OLD ORCHARD BEACH March 2019 PLANNING BOARD MEMO

March 2019 Planning Board Memo: Table of Contents

Proposal: Conditional Use: Accessory Dwelling Unit
Action: Final Ruling
Owner: The Village at Pond View Woods, LLC
Location: 206 Portland Ave, MBL: 103-1-432

Proposal: Minor Subdivision: 2 Duplex Dwellings with a Total of 4 Residential Units
Action: Ruling on Preliminary Plan, Ruling on Final Plan
Owner: Donald Bouchard
Location: 189 Saco Avenue, MBL: 208-3-12

Figure 1: New Proposal (January 2019)

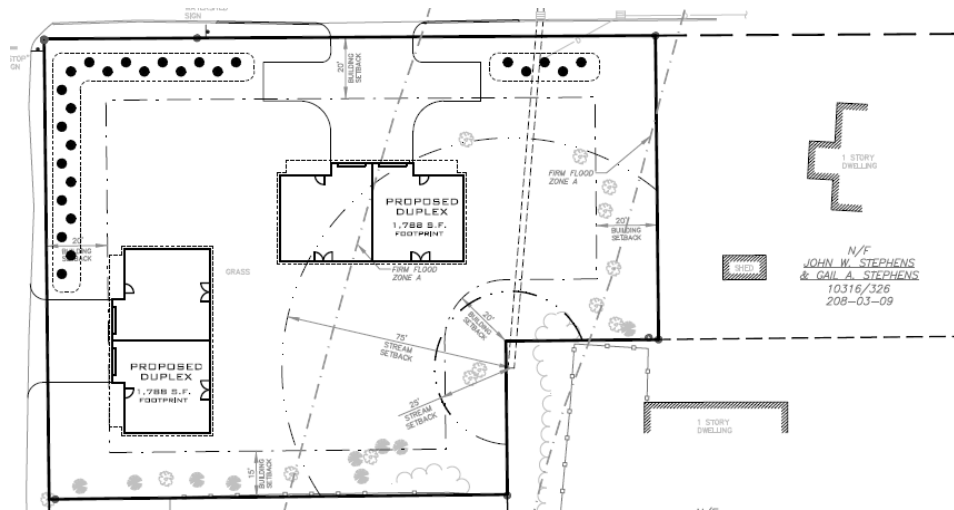
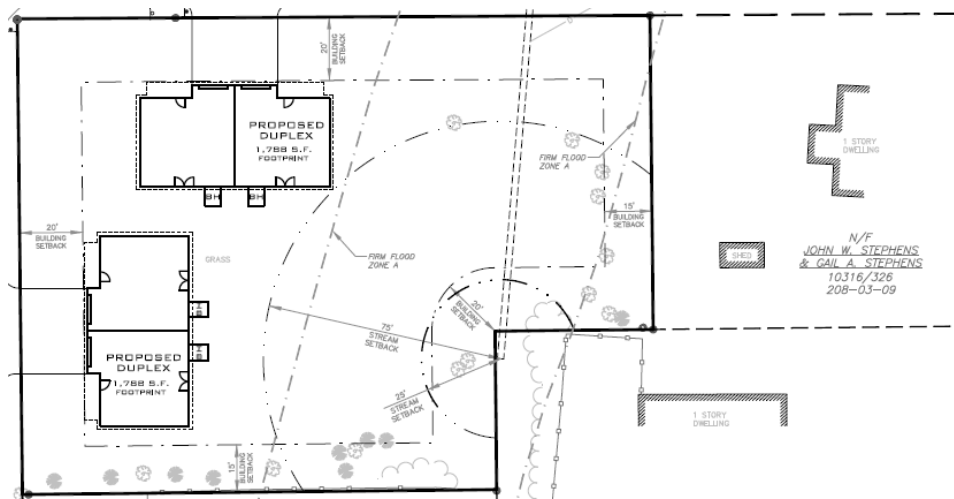
The Planning Board last saw this proposal back in August of 2018. It is for the construction of 2 duplexes on the corner of Macarthur Ave and Saco Ave. Below are the plans for the original vs. new proposal. The big difference is the addition of a t-turnaround for the duplex that egress onto Saco Avenue.

At the August meeting, there was a concern regarding parking. Sec. 78-806(a)(1) states no parking shall be permitted in the front setback yard. At the time both duplexes showed driveways in the front setback. In the 2019 update, it appears the Duplex fronting Saco Avenue have removed parking in the front setback, however, the duplex on Macarthur Avenue is still showing parking in that front setback. We are not aware of a driveway exemption or waiver. Planning Staff has recommended the Applicant apply for a Variance through the ZBA.
